PG&E Letter DCL-15-142

Response to NRC Letter dated November 5, 2015, "Request for Additional Information Related to the Environmental Review of the Diablo Canyon Power Plant, Units 1 and 2, License Renewal Application (CAC Nos. MF4019 and MF4020)"

Pacific Gas and Electric Company's Response to Nuclear Regulatory Commission's "Request for Additional Information Related to the Environmental Review of the Diablo Canyon Power Plant, Units 1 and 2, License Renewal Application," dated November 5, 2015

Figure AIR-7-9

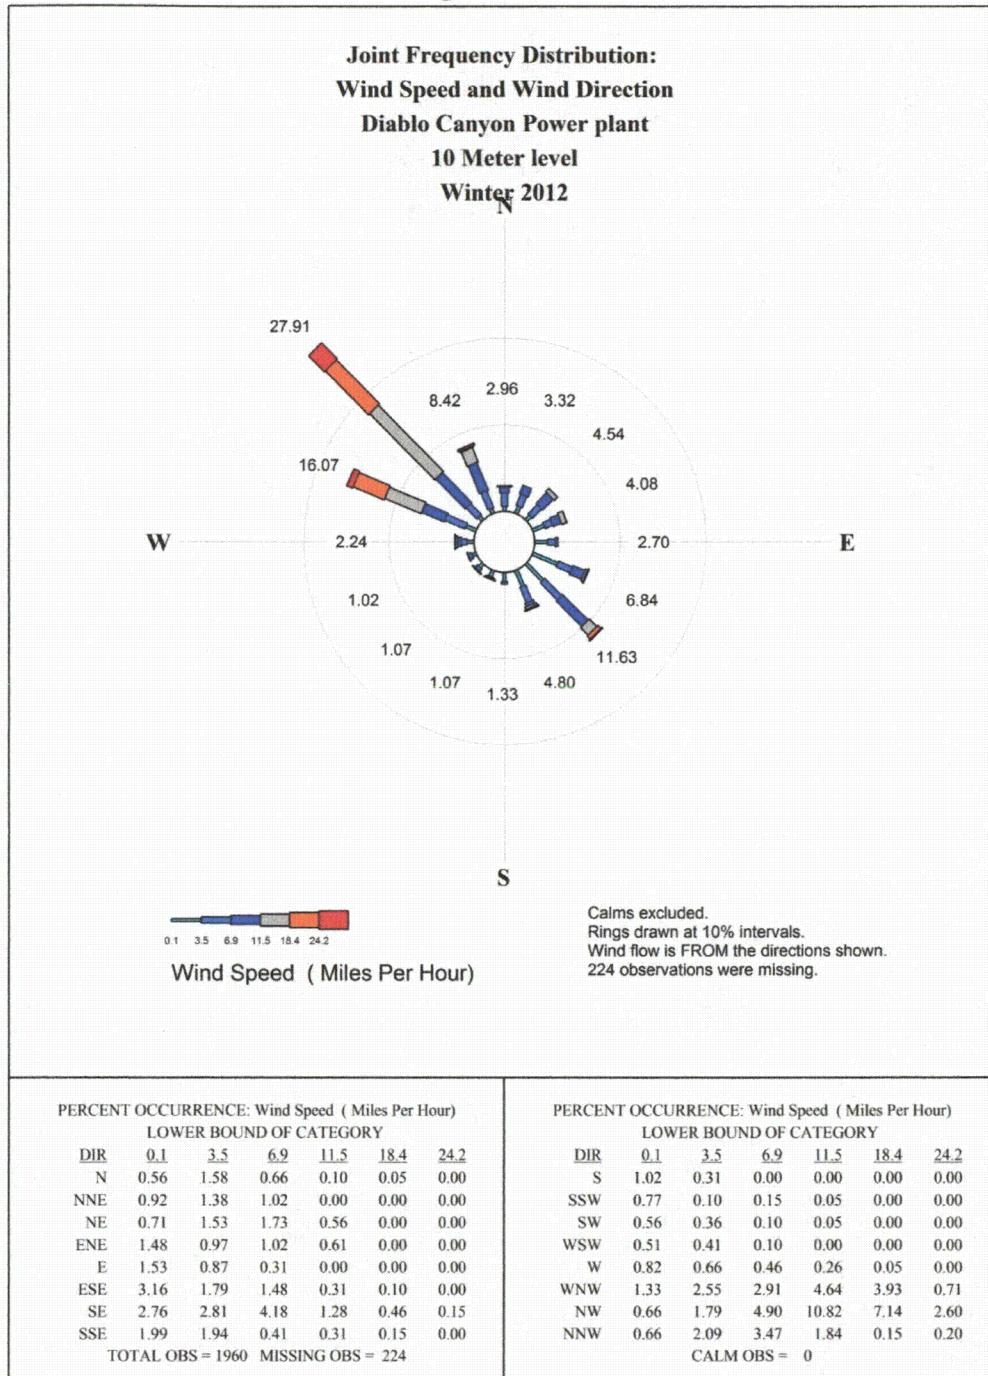
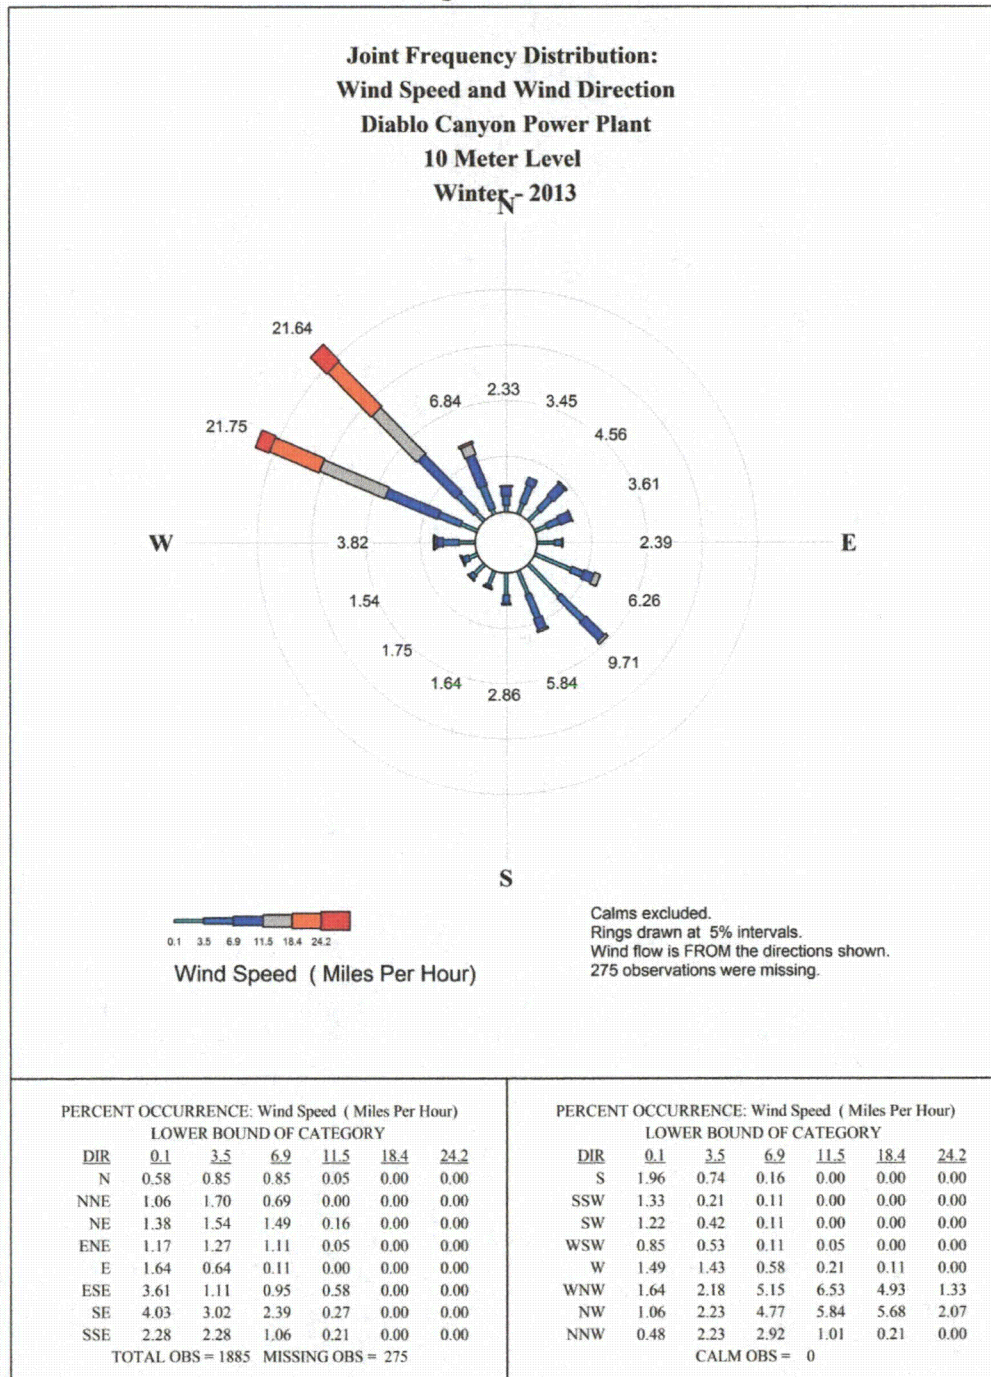
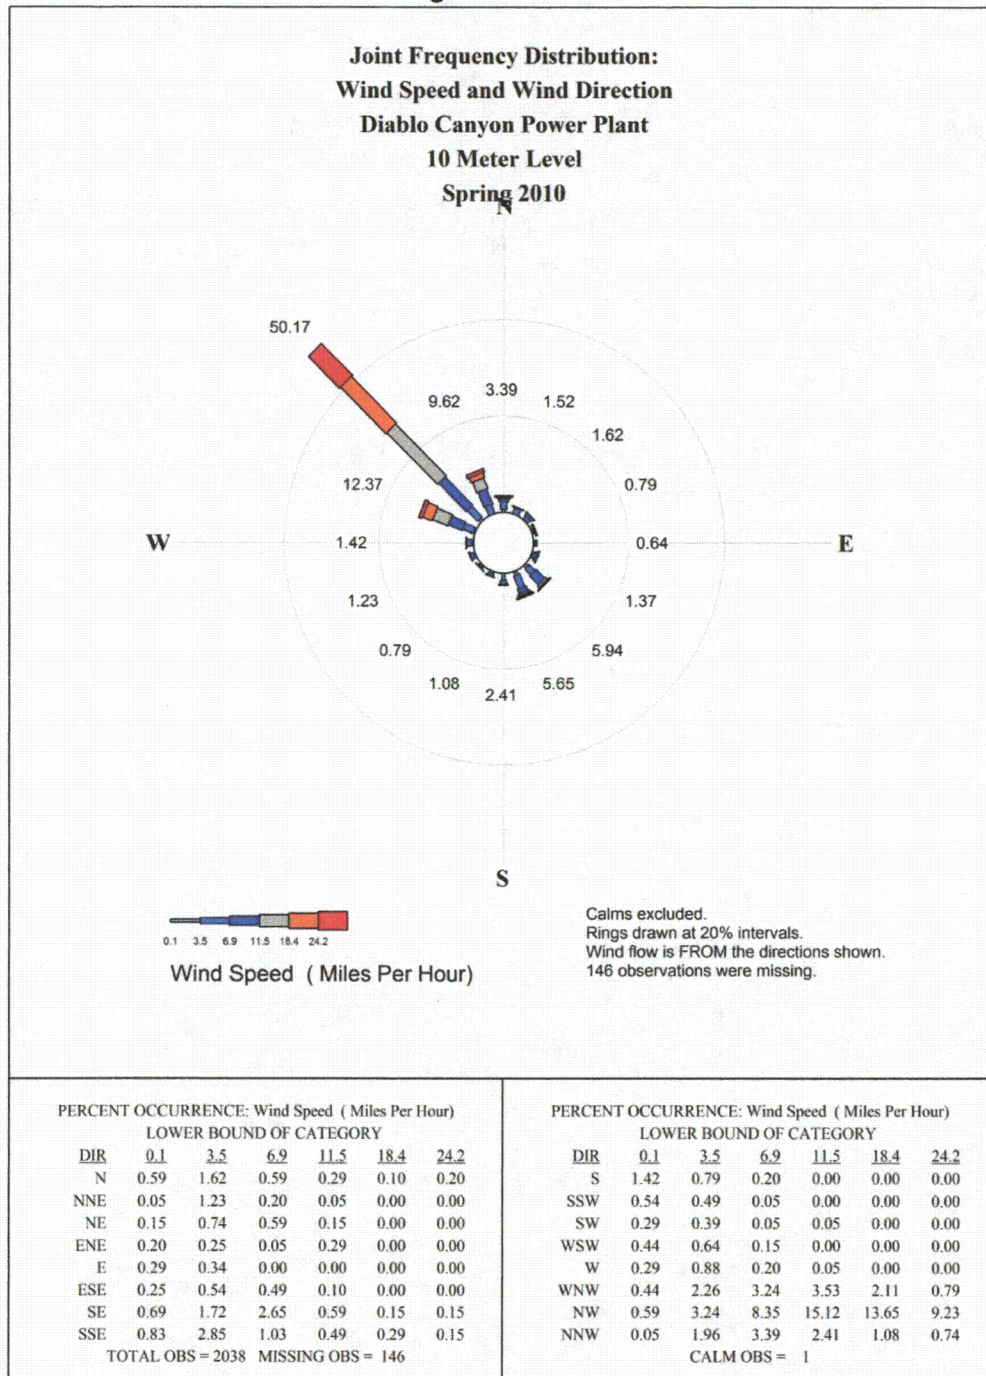
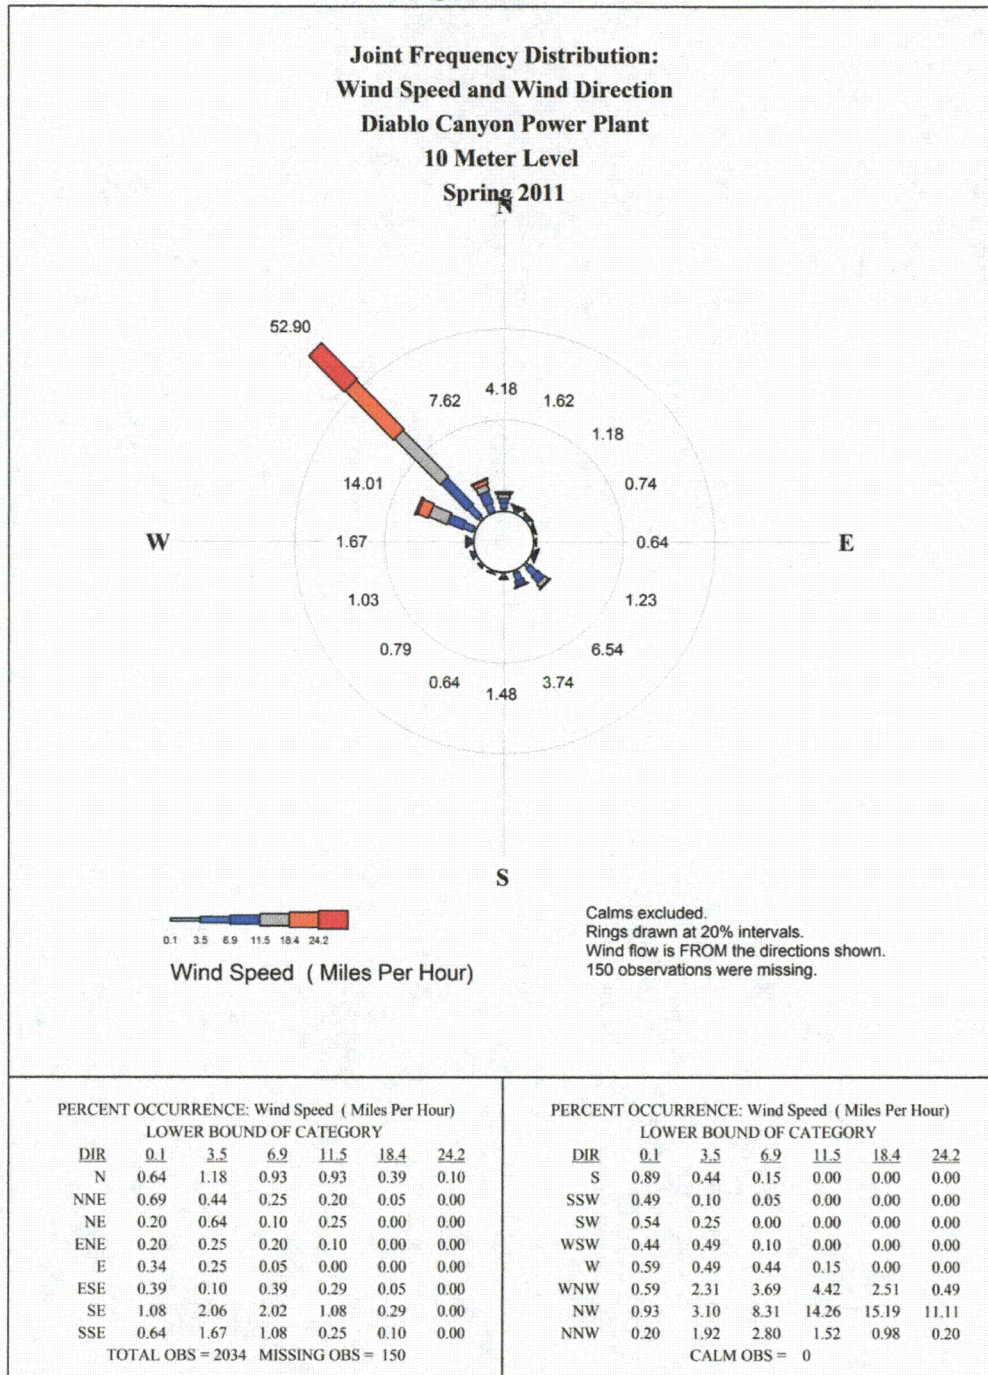
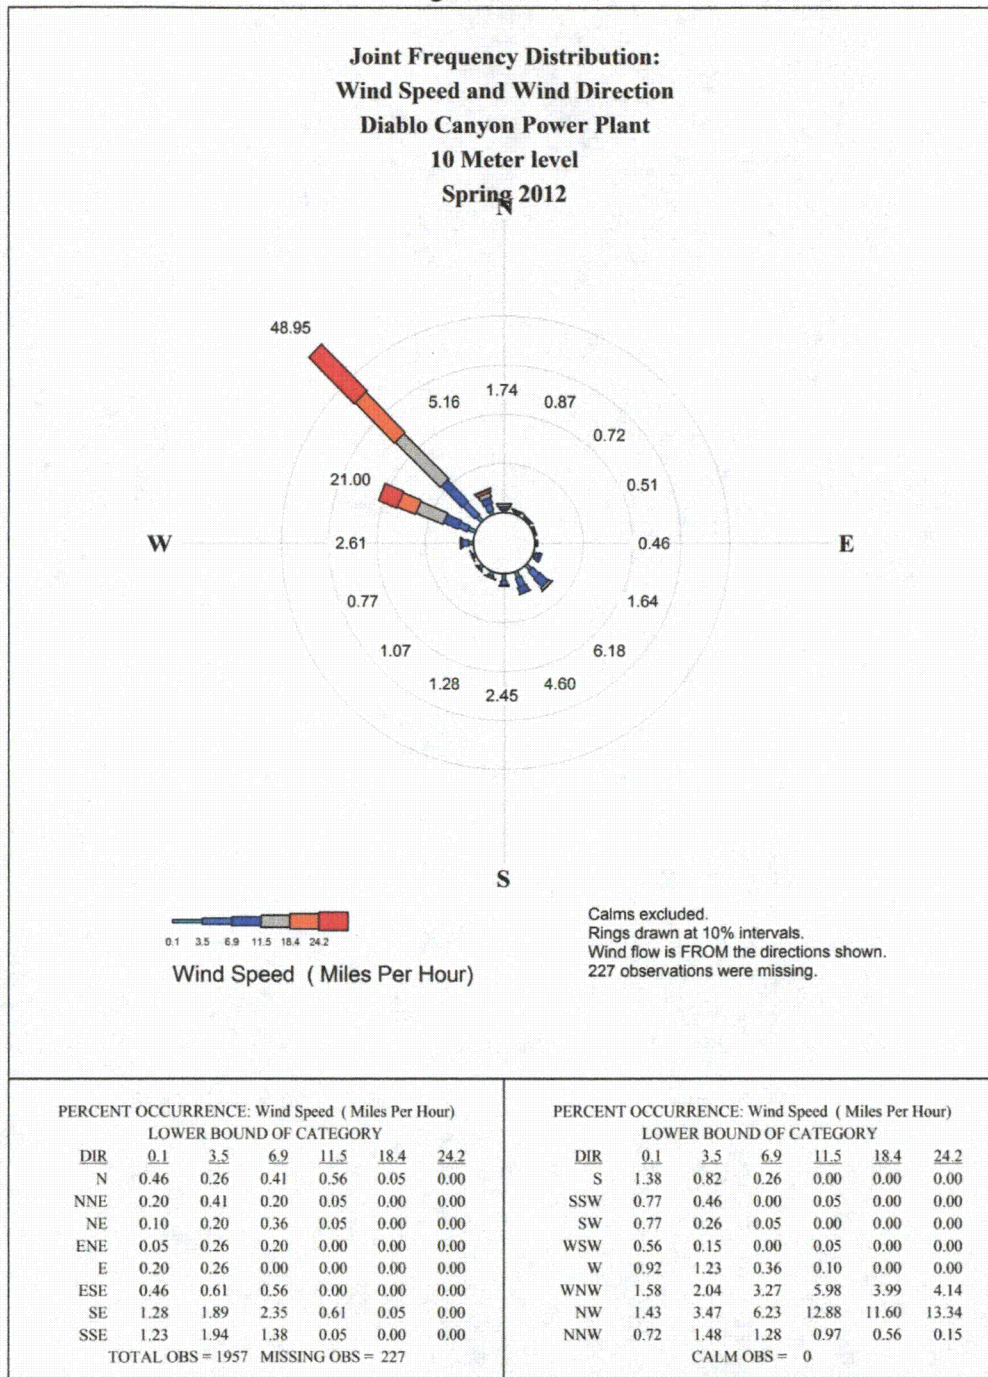
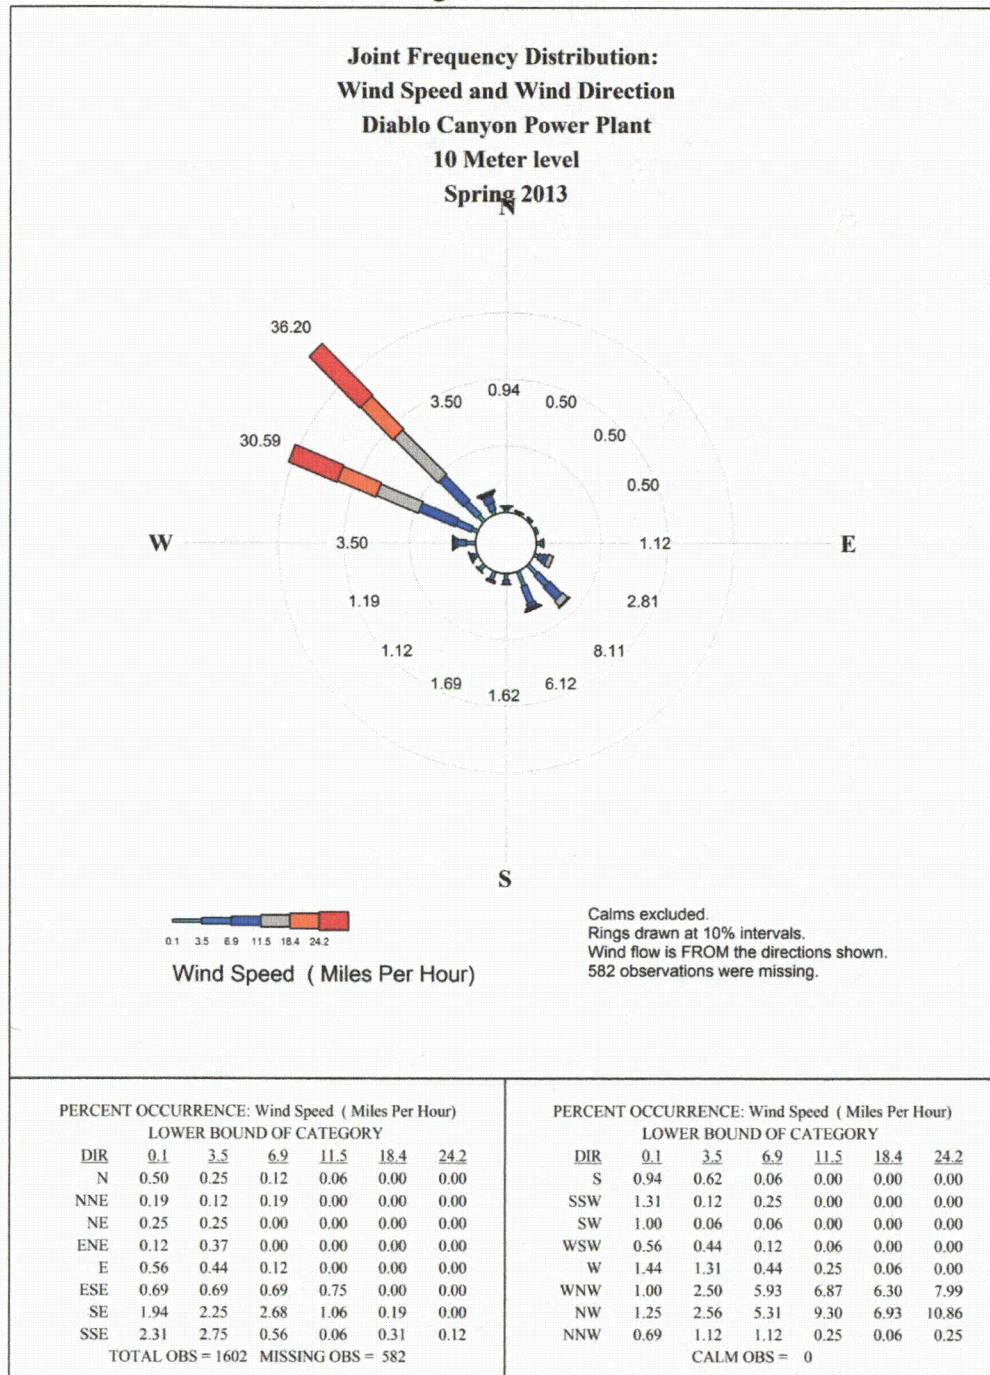
Provide seasonal and annual summary wind statistics in the form of wind direction and speed frequency distribution tables and wind roses from data recorded at DCP's meteorological facility. Discuss predominant wind direction and speed by season and annual average. The meteorological data should include the most recent 5 years for which the data are available.

The annual and seasonal wind direction frequency of occurrence for the DCP primary tower 10-m level for the period 2010 to 2014 are presented in Attachment 2, Tables AIR-7-1 through AIR-7-5. Annual and seasonal wind roses for DCP for the 2010 to 2014 periods are presented in Attachment 1 Figures AIR-7-1 through AIR-7-25. The wind rose presents the joint frequency of wind speed and wind direction recorded at the 10-m level at the plant. The wind direction is presented in 16 principal directions (north, north-northeast, northeast, north northwest) with each direction category encompassing a 22.5-degree sector centered on that direction. Six wind speed categories are used with the lower bounds at 0.1, 3.5, 6.9, 11.5, 18.4, and 24.2 miles per hour (mph). The length of each color band represents the frequency of a specific wind speed range. For example, northwesterly winds greater than 24.2 mph occurred 4.1 percent of the time for the period 2010 to 2014. Furthermore, below each wind rose diagram, is the same data displayed in table form for a more detailed breakdown of the seasonal wind direction and speed frequency distribution.
